PLANNING COMMISSION AGENDA

May 3, 2022 - 6:00 p.m.

Item VII-B: Public hearing & consideration of a Site Plan & Architectural Review for Scenic Middle School Parking Lot Improvements

**JACKSON COUNTY
 DISTRICT #6
 SCENIC MIDDLE
 SCHOOL PARKING
 LOT IMPROVEMENTS**

Attachment "A-1"

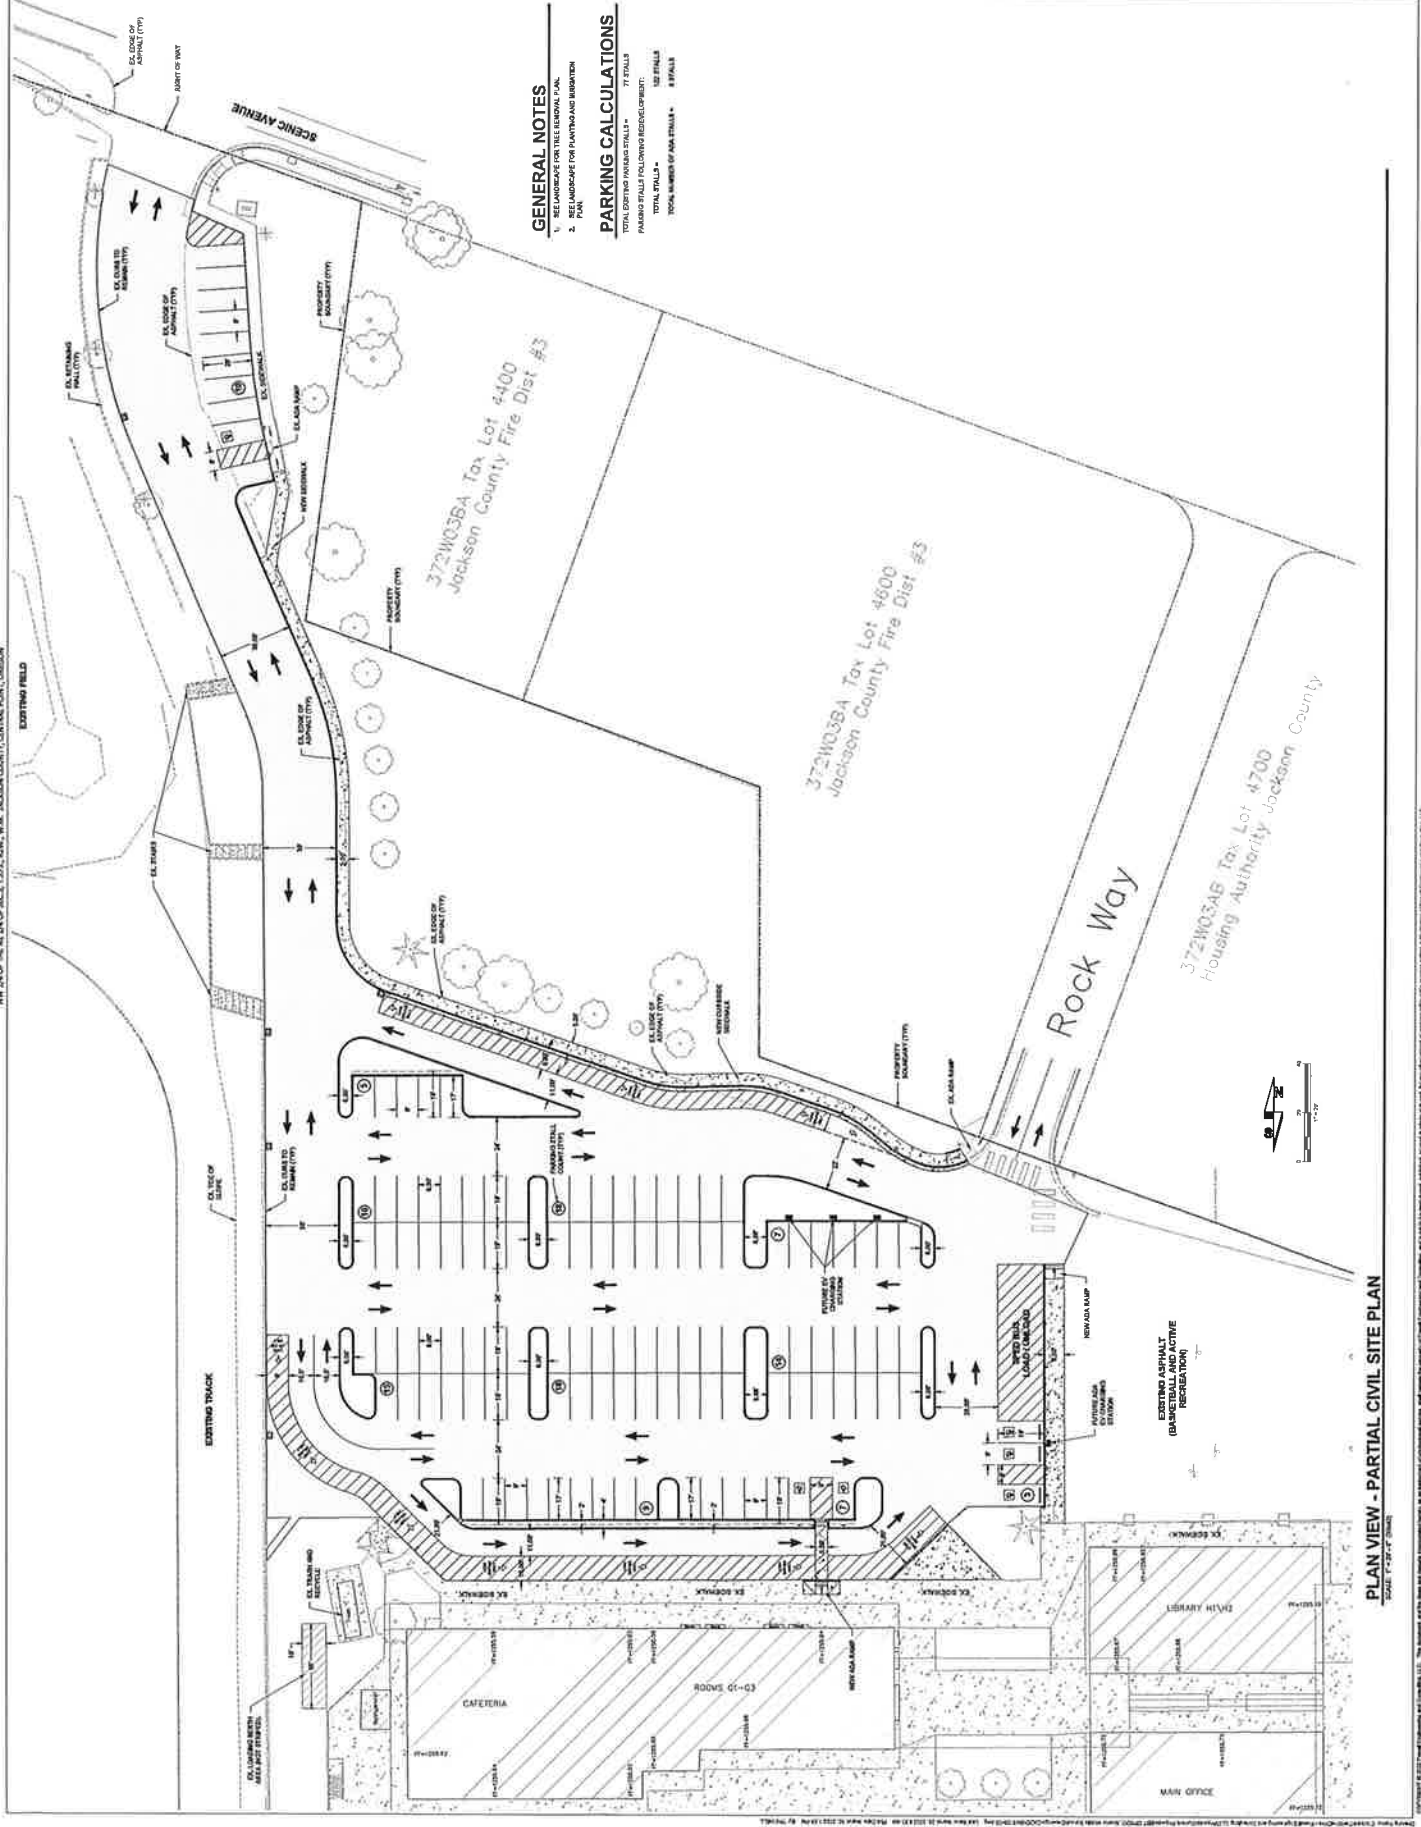
2. **Fire Lane & Aerial Apparatus.** The site plan shows a 21-ft wide fire lane that is closer to the structure than the prescribed 15-foot separation required and may not provide adequate clear area to accommodate aerial apparatus per the Fire Code. Per Fire District #3 (Attachment "E") the fire lane must provide adequate clear area in order to deploy a ladder (e.g. aerial apparatus) for fire suppression/rescue efforts.

Comment: To meet the Fire Code requirements per the FD3 comments it will be necessary to ensure the fire lane remains clear and unobstructed. Staff recommends a condition of approval requiring the applicant to install signage identifying the fire lane as an area of 'no parking' and prohibiting unattended vehicles.

1. The new parent flow through isle will become the new fire lane.
2. Ensure the new parent flow through isle meets the requirements for aerial apparatus access. Specifically, 28 feet of clear width to park and set up the ladder truck. The 28 feet cannot begin closer than 15 feet nor begin farther than 30 feet from the building. Landscaping and trees cannot extend into the required width. Reference 2019 Oregon Fire Code Appendix D, Section D105.3.
3. No unattended parking will be allowed at any time in the new parent flow through isle. Provide signage and information to parents and staff to ensure no unattended parking will occur at any time. Unattended vehicles in the pickup isle are subject to being towed. School Dist. 6 is responsible to enforce the parking restriction.

Attachment “A-4” – Landscape Plan

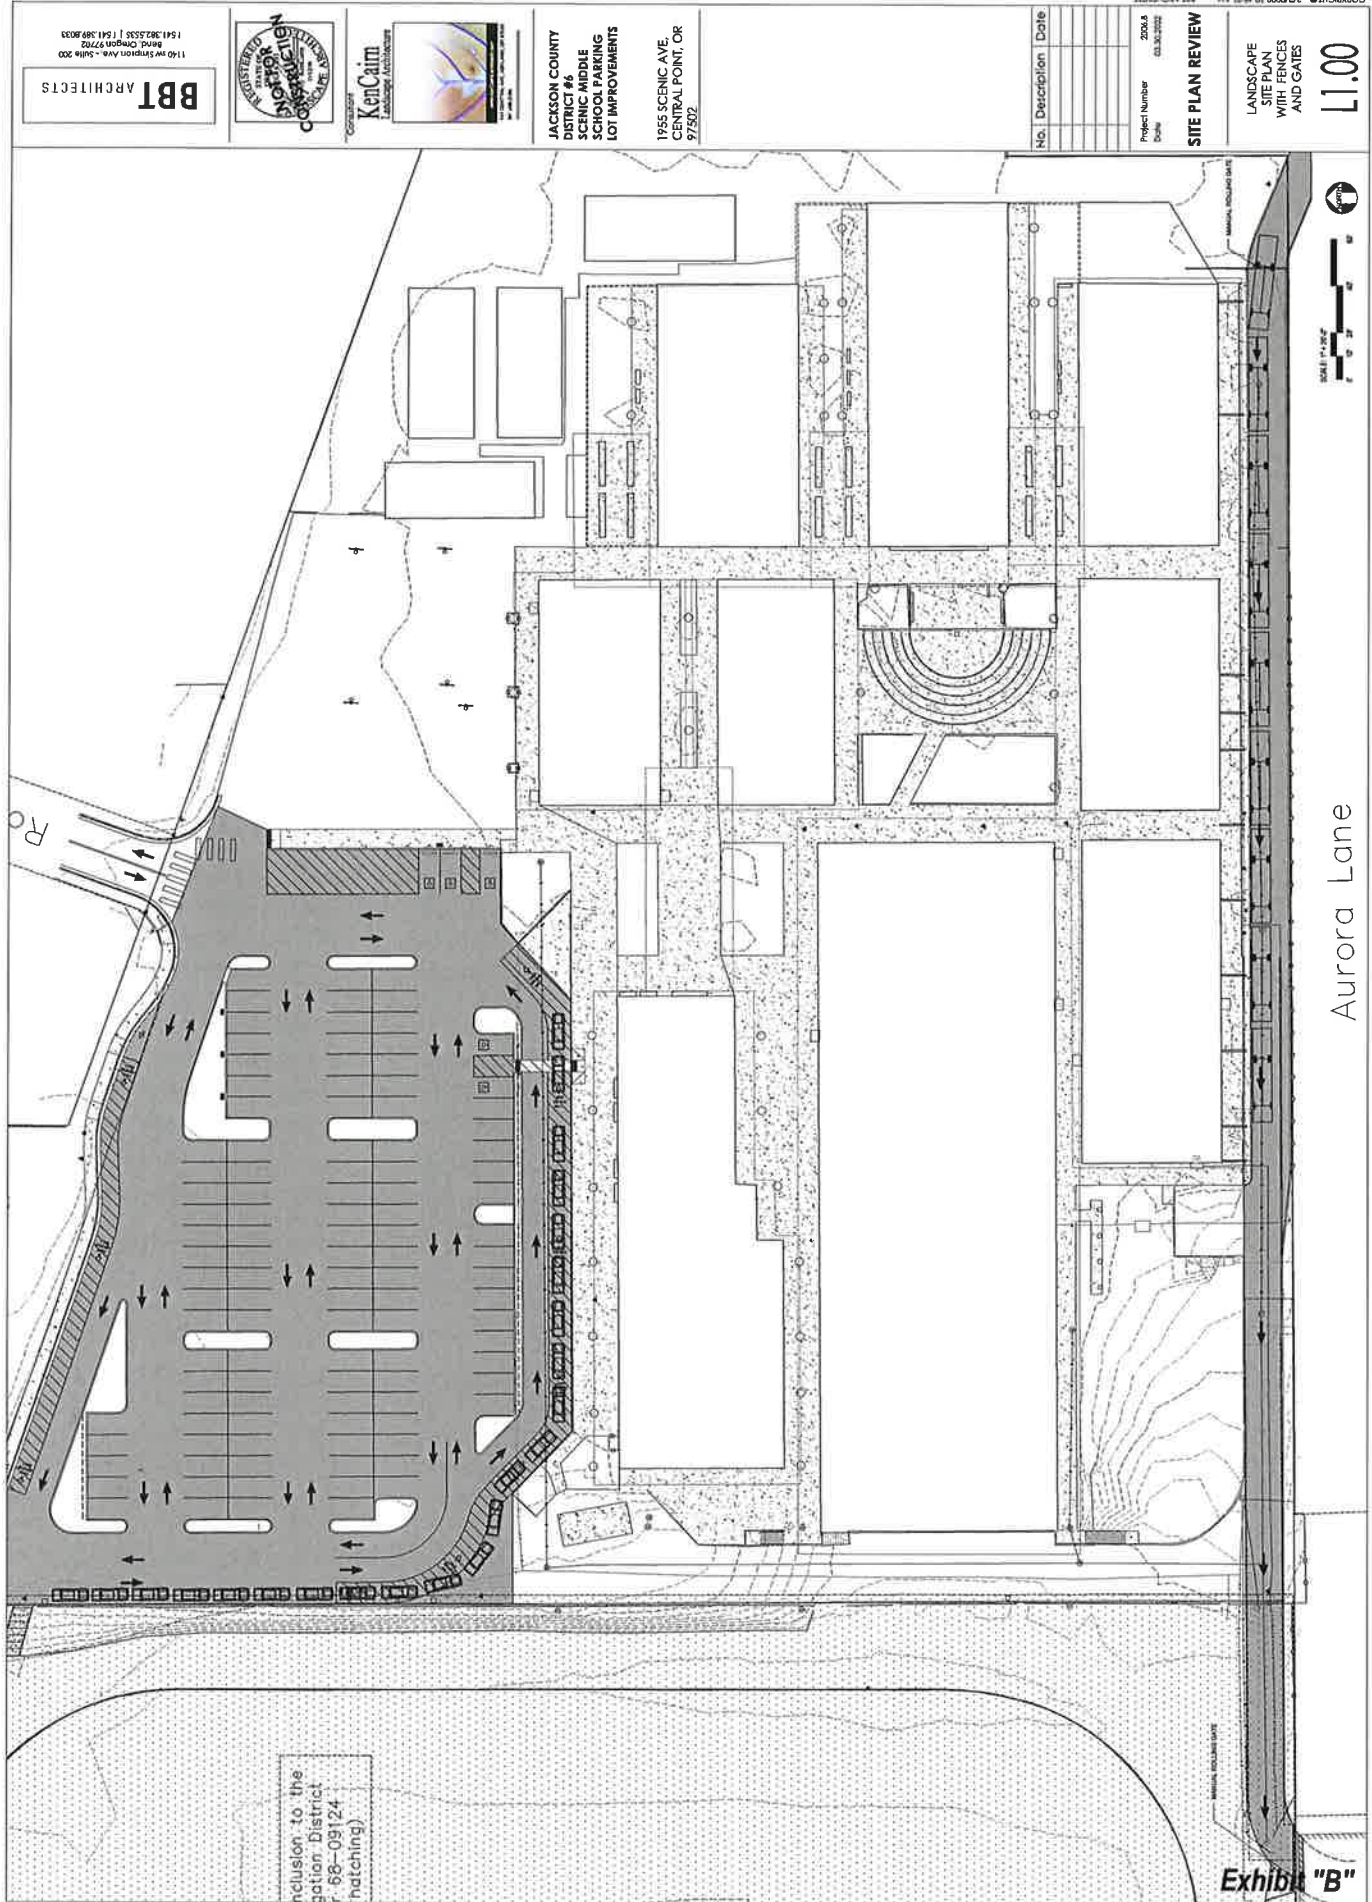
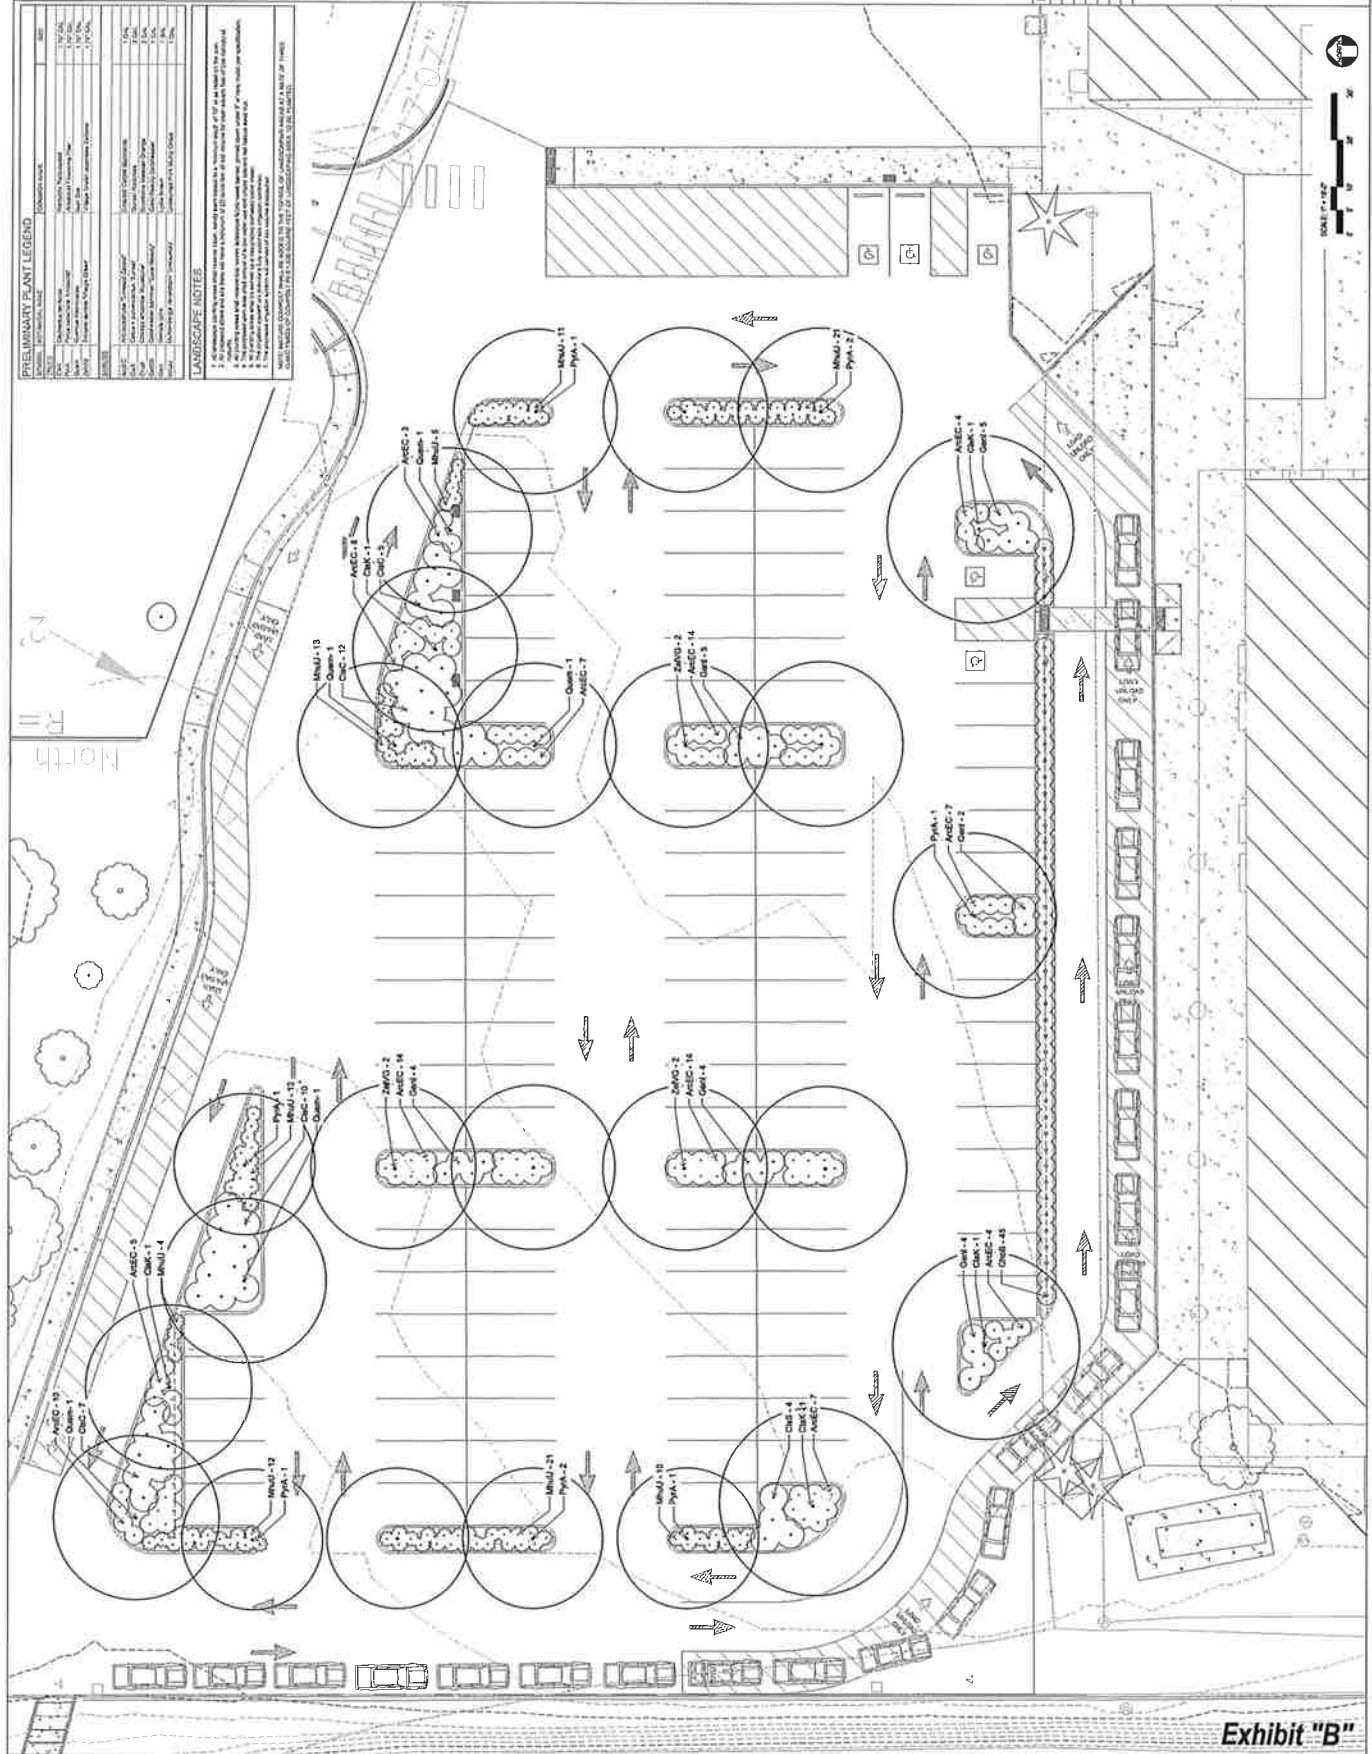
1. **Landscape Plan.** The landscape plan depicts perimeter and interior landscape areas (Attachment "A-4"). The proposed parking area improvements are located between the structure and public right-of-way, requiring at least one tree for every four parking spaces, per CPMC 17.75.039(G)(2). The landscape plan depicts 25 trees in the reconfigured parking area where a total of 31 trees are required for the 122 parking spaces.

Perimeter landscape improvements, including existing and installed trees, must comply with Table 17.75.03 in CPMC 17.75.039(G). The application specifies that existing mature vegetation is being used to count toward meeting the street frontage planting requirements between the new angled parking area and Scenic Avenue. The proposed sidewalk east of the angled parking area may result in mortality of the mature trees. In the event of tree mortality, the parking area will not comply with the landscape standards.

Comment: Staff recommends Condition of Approval No. 1(a) requiring the applicant to submit a revised landscape plan that depicts a minimum of 31 trees in the reconfigured parking lot area and depicts how the mature trees will be replaced in the event the trees do not survive through development of the site. Staff also recommends Condition of Approval No. 2(a) that requires the applicant to certify the health of the mature trees prior to Certificate of Occupancy and to replace the trees if they are not in good health.

1. Prior to building permit issuance for the Parking Lot Improvements, the applicant shall satisfy the following conditions of approval:
 - a. Submit a revised landscape plan that depicts a minimum of 31 parking lot trees and additional trees and shrubs to replace the mature trees along the existing access in the event the existing trees do not survive through development.
